SERVICE BULLETIN

ATA CODE 11-30

TITLE: PLACARDS AND MARKINGS - INSTALLATION OF FUEL SELECTOR PLACARD

Figure 1

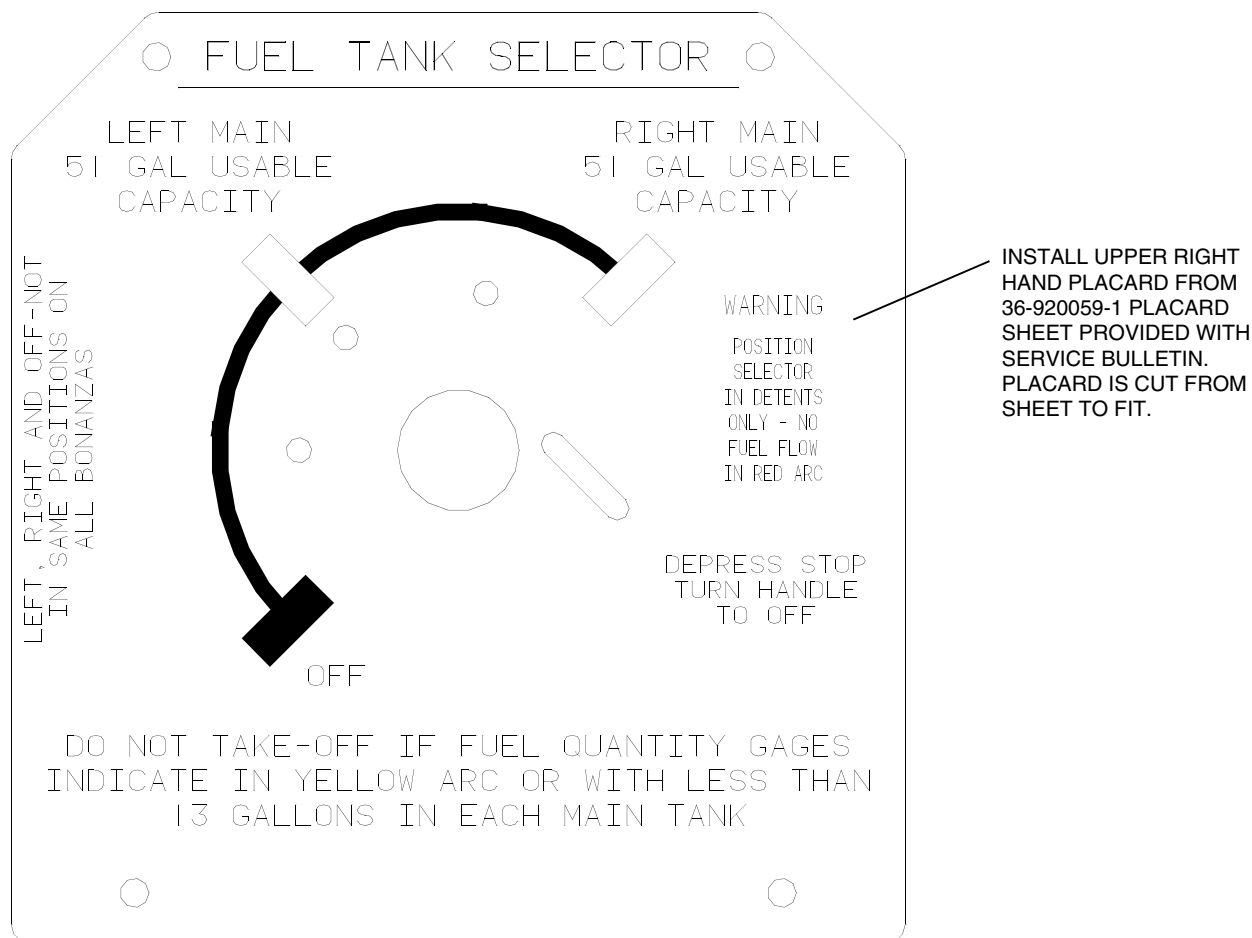
- (1) Figures 1 and 2 (and matching placards attached) are to be used primarily for the serials shown but may be used as an example of suitable configurations for typical Beech single-engine and twin-engine Beech airplanes. The no-flow sectors include the areas between tank detents and any "OFF" selection. Ensure that the placard does not cover any existing words or markings.

FUEL SELECTOR VALVE
(B36TC SHOWN, A36TC SIMILAR)

EFF: A36TC SERIAL EA-1 THRU EA-241 AND EA-243 THRU
EA-272 WITH BEECH KIT NO. 36-9008-1 INSTALLED,
KIT SERIAL NUMBERS 101 THRU 389 ONLY. B36TC
SERIALS EA-242 AND EA-273 THRU EA-591.

Figure 2

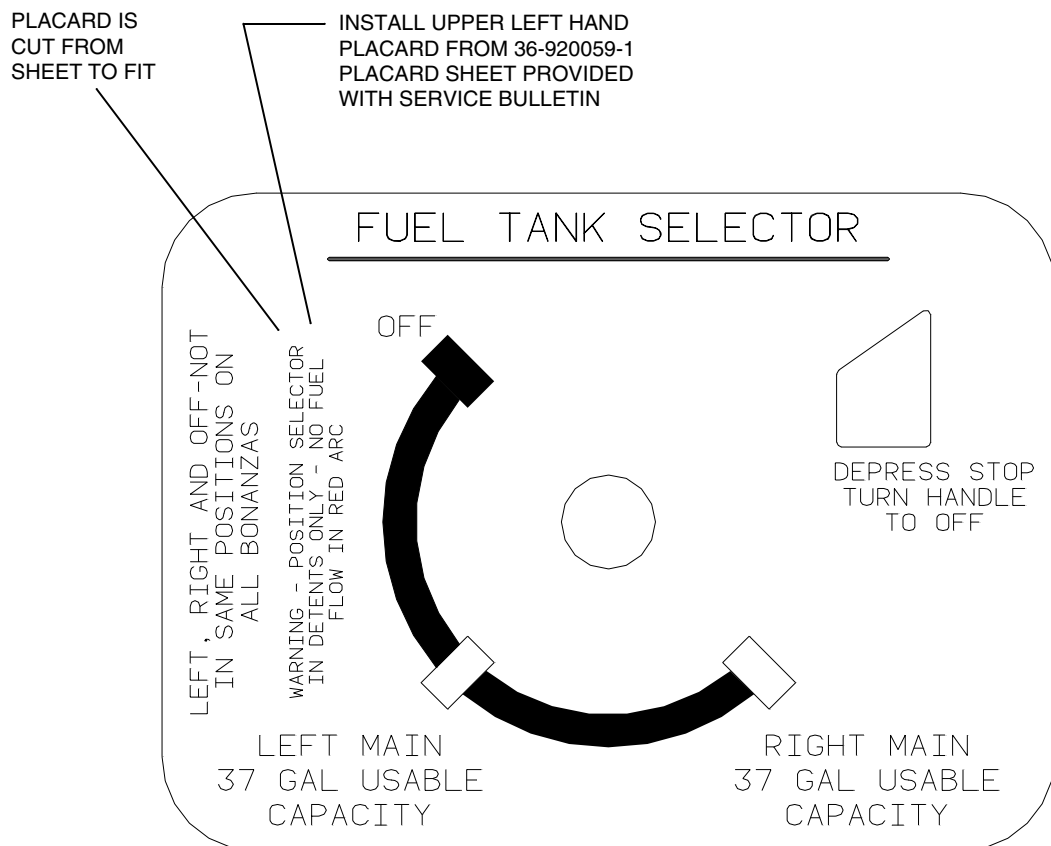
FUEL TANK SELECTOR COVER

EFF: F33A - CE-1014 THRU CE-1791
F33C - CJ-156 THRU CJ-179
A36 - E-2062 THRU E-3046
